PROPOSED TECHNICAL SPECIFICATION (TS) CHANGE

SEQUOYAH NUCLEAR PLANT UNITS 1 AND 2

DEPARTURE FROM NUCLEATE BOILING RATIO (DNBR) LIMITS BASES CHANGE

- 1) NUCLEAR PLANT(S): Sequoyah Units 1 and 2
- 2) SUBJECT (TITLE): Increased F Delta H from 1.55 to 1.62, Increased FQ From 2.32 to 2.4, With Mini RTDP
- 3) The written safety evaluation of the revised procedure, design change or modification required by 10CFR50.59(b) has been prepared to the extent required and is attached. If a safety evaluation is not required or is incomplete for any reason, explain on Page 2.

SEQUOYAH
FINAL SAFETY ANALYSIS REPORT
UNITS 1 and 2
Startup of an Inactive Reactor Coolant Pump
Active Loop Flow vs. Time;
Core Flow vs. Time
Figure 15.2.6-1

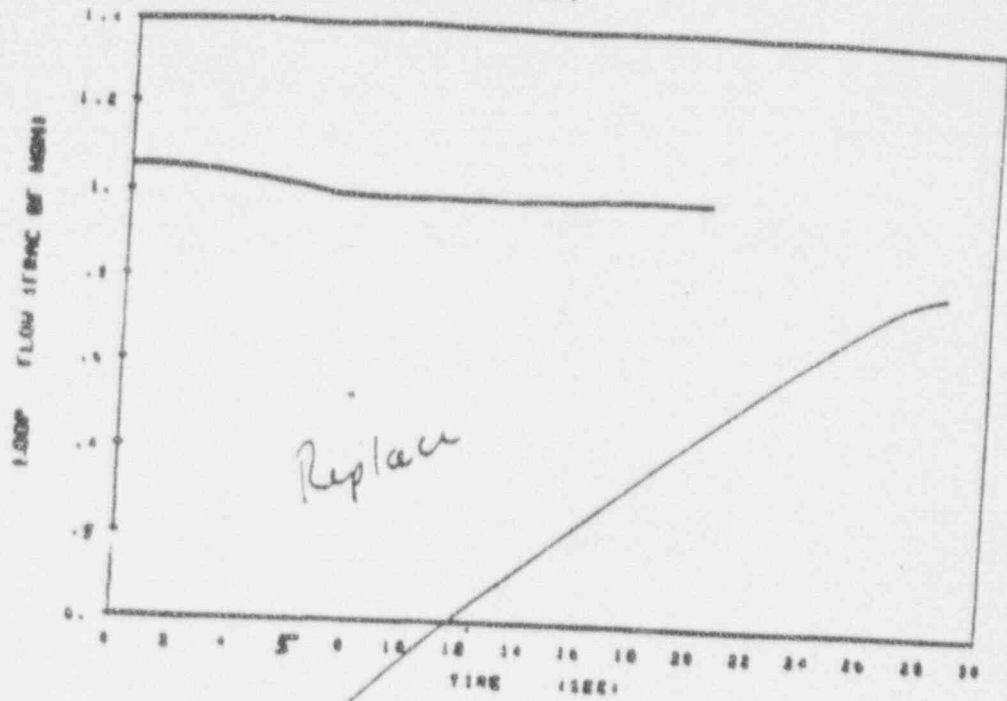
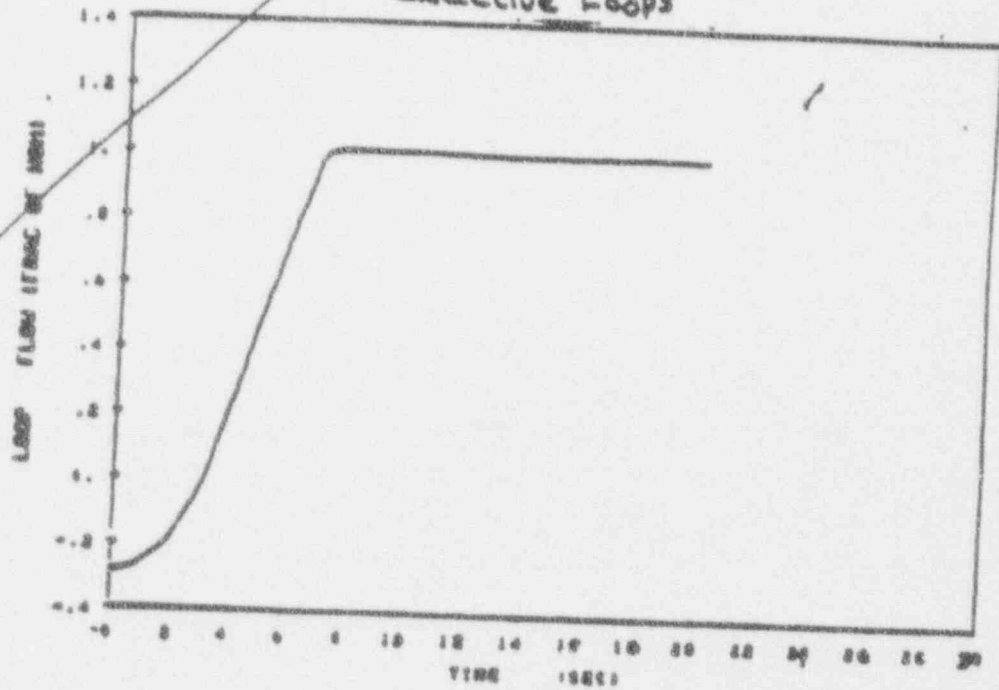
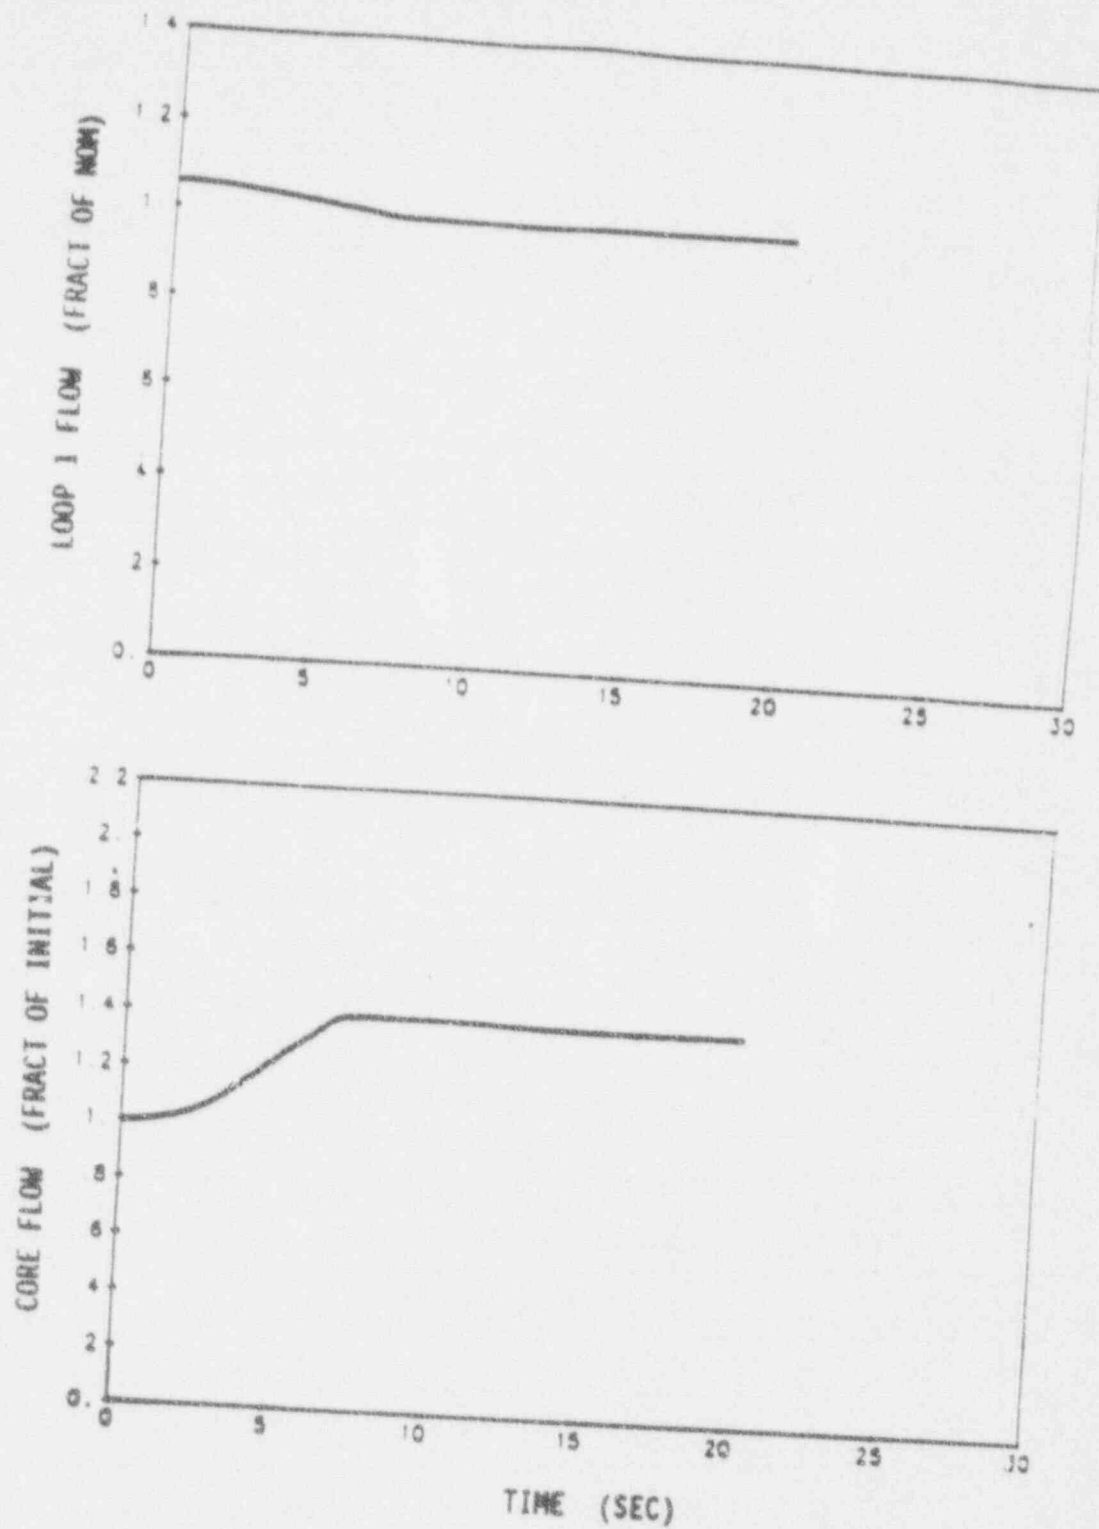
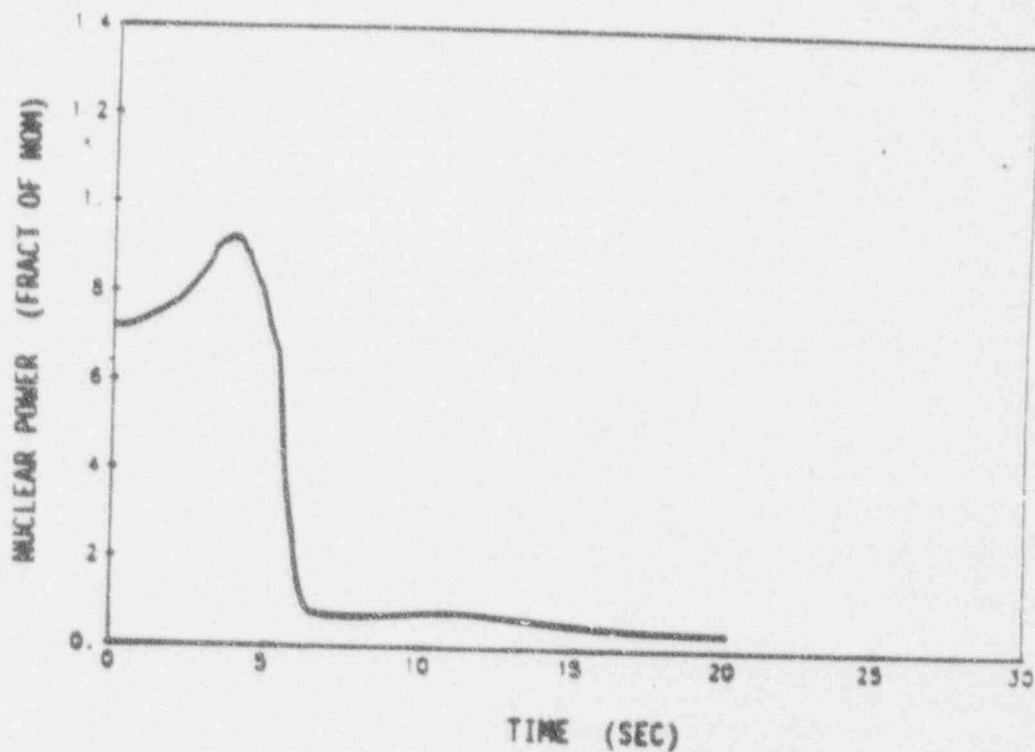
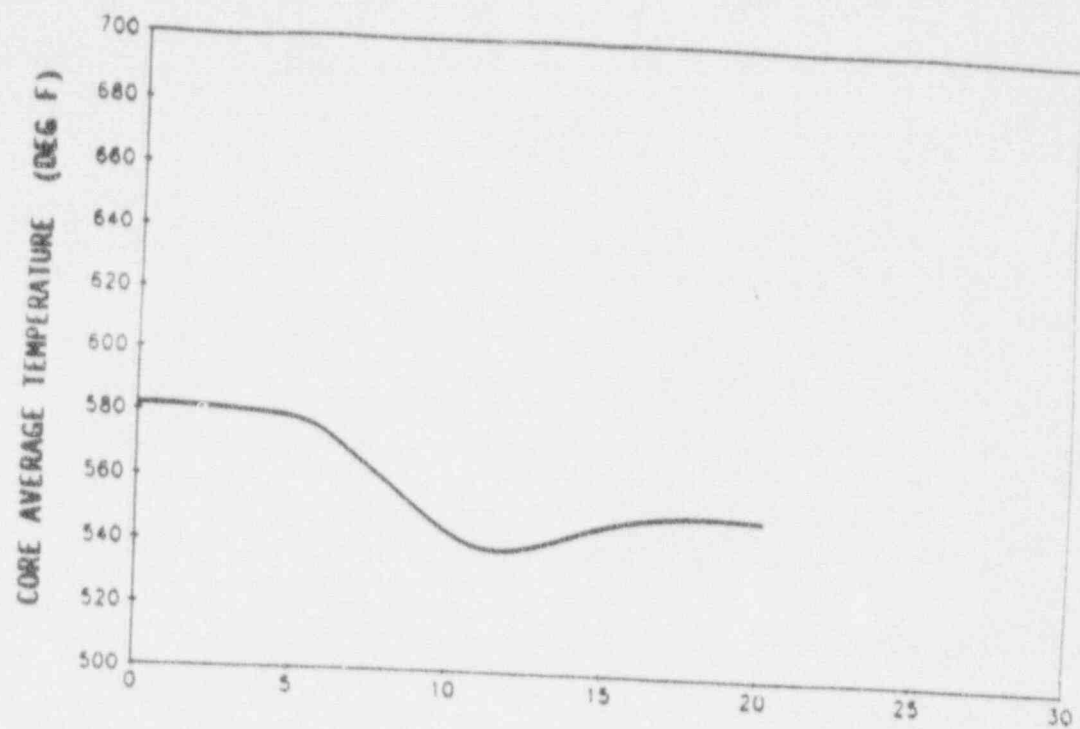
9.1.2 For the Startup of an Inactive Reactor Coolant Pump the following changes were made: Reference 3 updated, Table 15.2-1 (sheet 3), and Figures 15.2.6-1 through 15.2.6-4 were replaced.

The calculated sequence of events for this accident is shown on Table 15.2-1. The transient results illustrated in Figures 15.2.6-1 through 15.2.6-4 indicate that a stabilized plant condition, with the reactor tripped, is approached rapidly. Plant cooldown may subsequently be achieved by following normal shutdown procedures.

SEQUOYAH FINAL SAFETY ANALYSIS REPORT UNITS 1 and 2
Complete Loss of Forced Reactor Coolant Flow Reactor Vessel Flow vs. Time
Figure 15.3.4-1

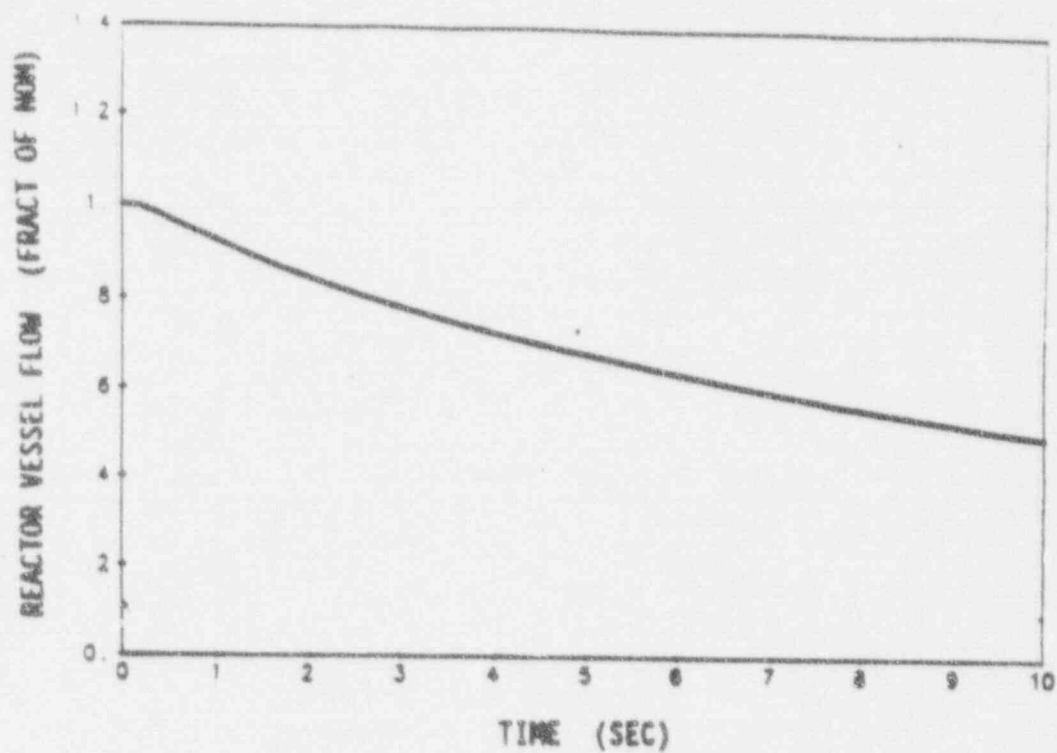
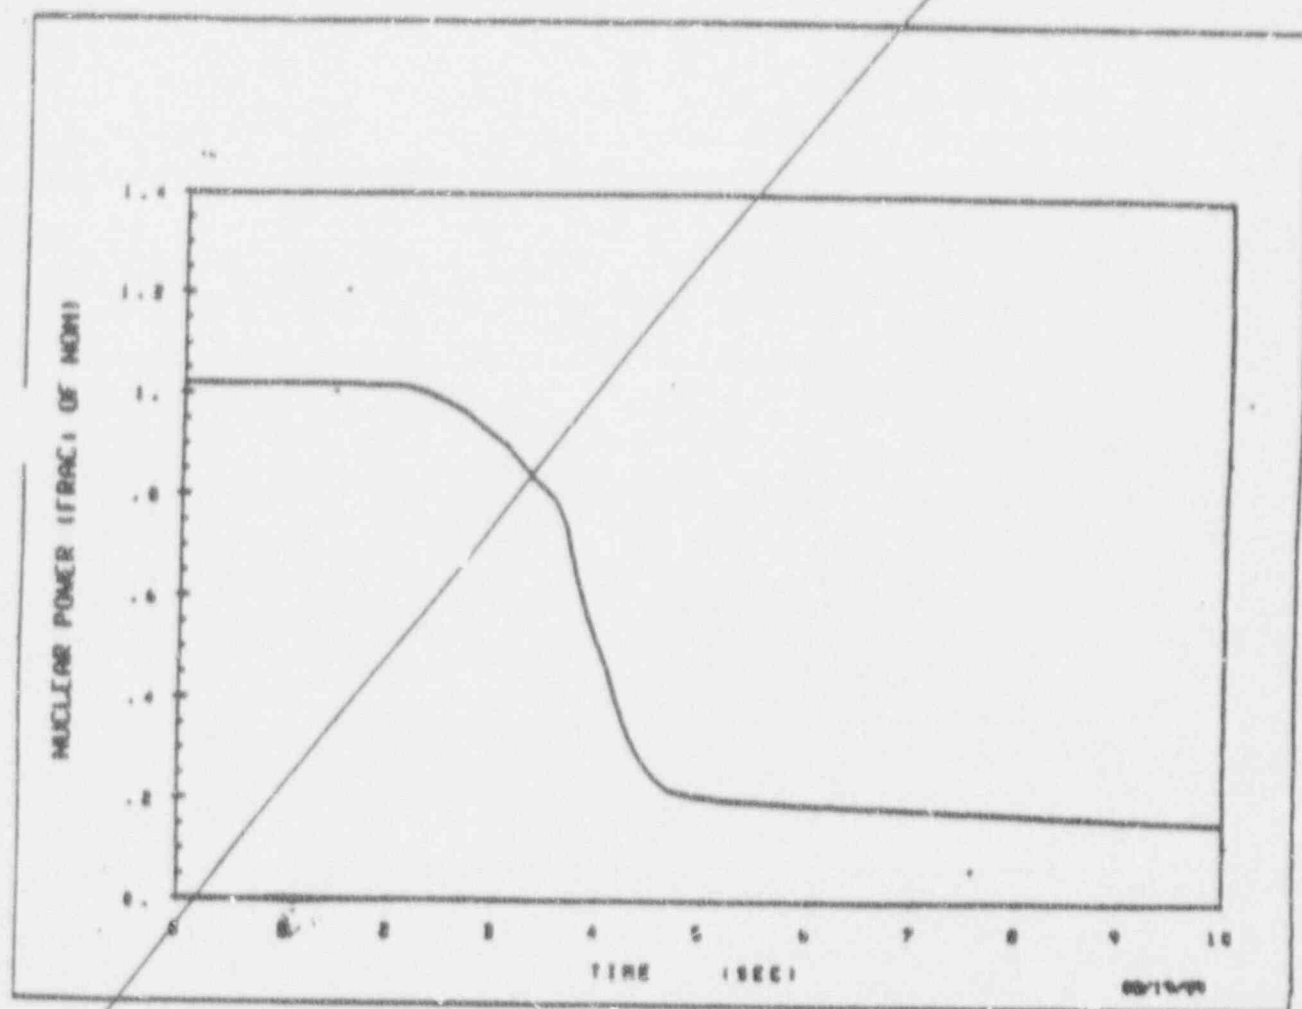
9.1.3 For the Complete Loss of Flow event the following changes were made: Text markups, Reference 8 updated, Table 15.3.4-1 revised, and Figures 15.3.4-1 through 15.3.4-3 were replaced.

REPLACE WITH THE FOLLOWING

The calculated sequence of events is shown in Table 15.3.4-1 for the limiting case analyzed. This case corresponds to a reactor trip occurring on a bus underfrequency condition. Figures 15.3.4-1 through 15.3.4-3 show the resulting transient conditions for the Complete Loss of Flow analysis. Included in these figures are total RCS flow, average and hot channel heat flux, nuclear power, and DNBR, each as a function of time. The minimum DNBR is not less than the safety analysis limit.

SEQUOYAH FINAL SAFETY ANALYSIS REPORT UNITS 1 and 2
Complete Loss of Forced Reactor Coolant Flow Nuclear Power vs. Time
Figure 15.3.4-2a

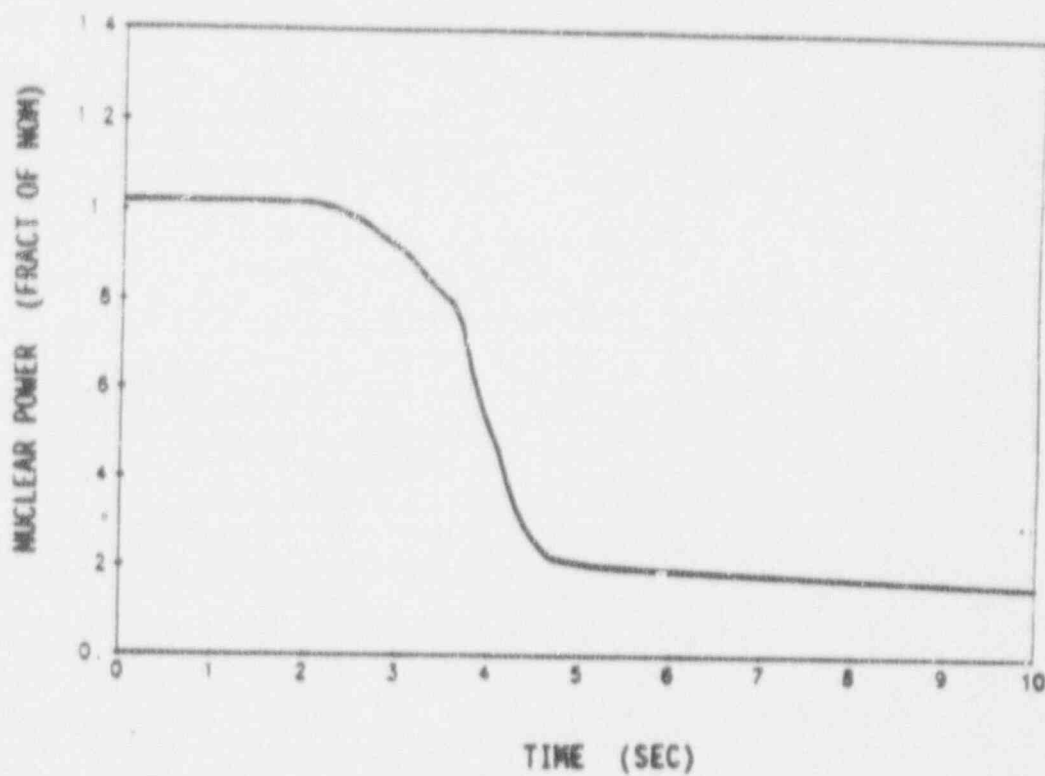
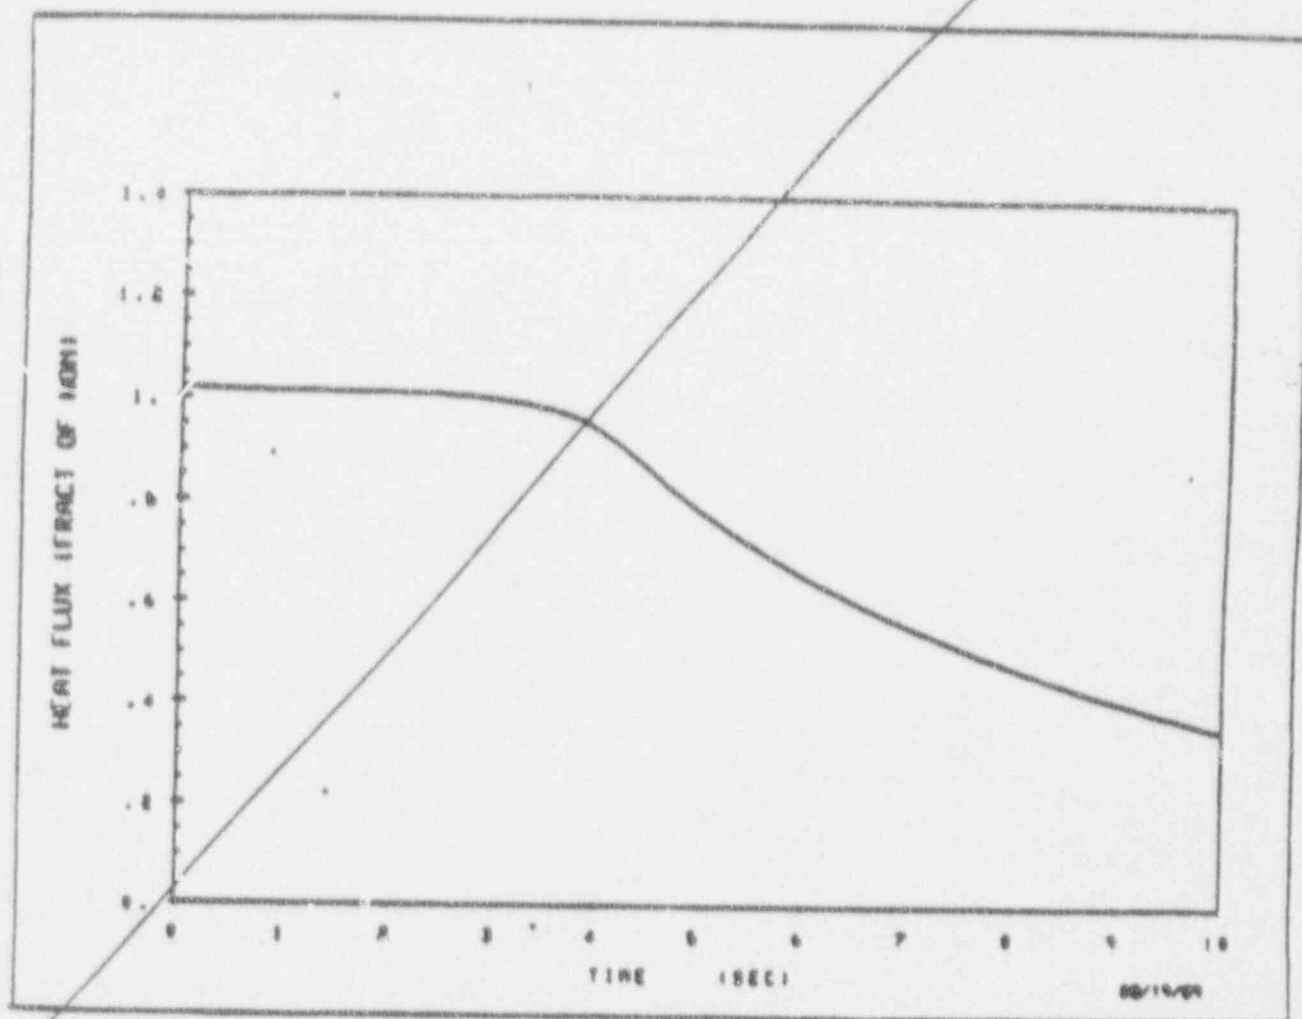
REPLACE WITH THE FOLLOWING

SEQUOYAH FINAL SAFETY ANALYSIS REPORT UNITS 1 and 2
Complete Loss of Forced Reactor Coolant Flow Heat Flux vs. Time (Average Channel)
Figure 15.3.4-2b

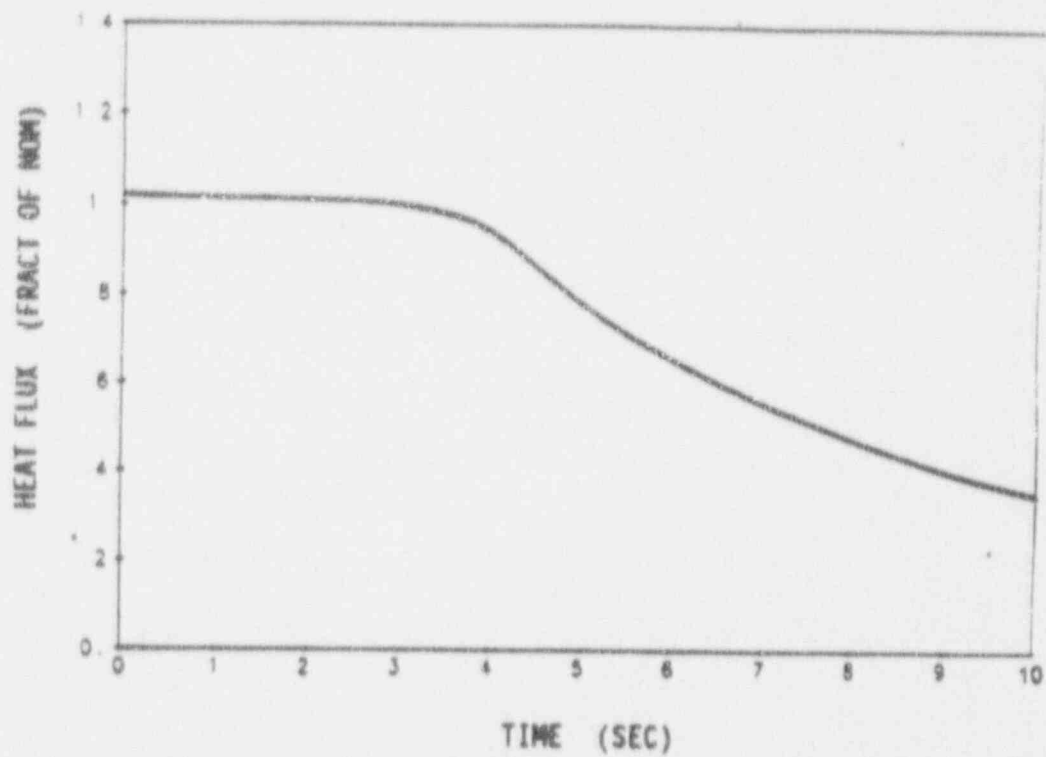
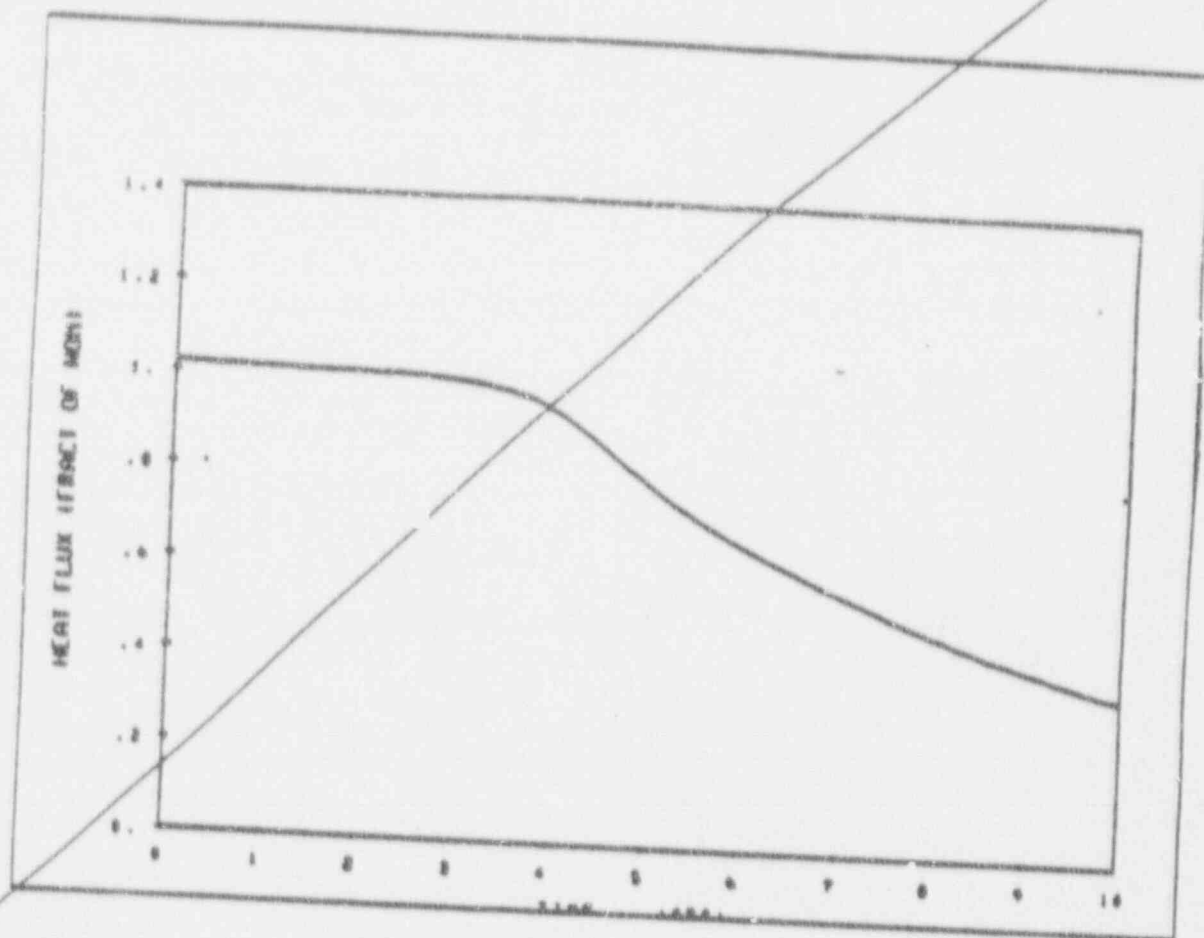
REPLACE WITH THE FOLLOWING
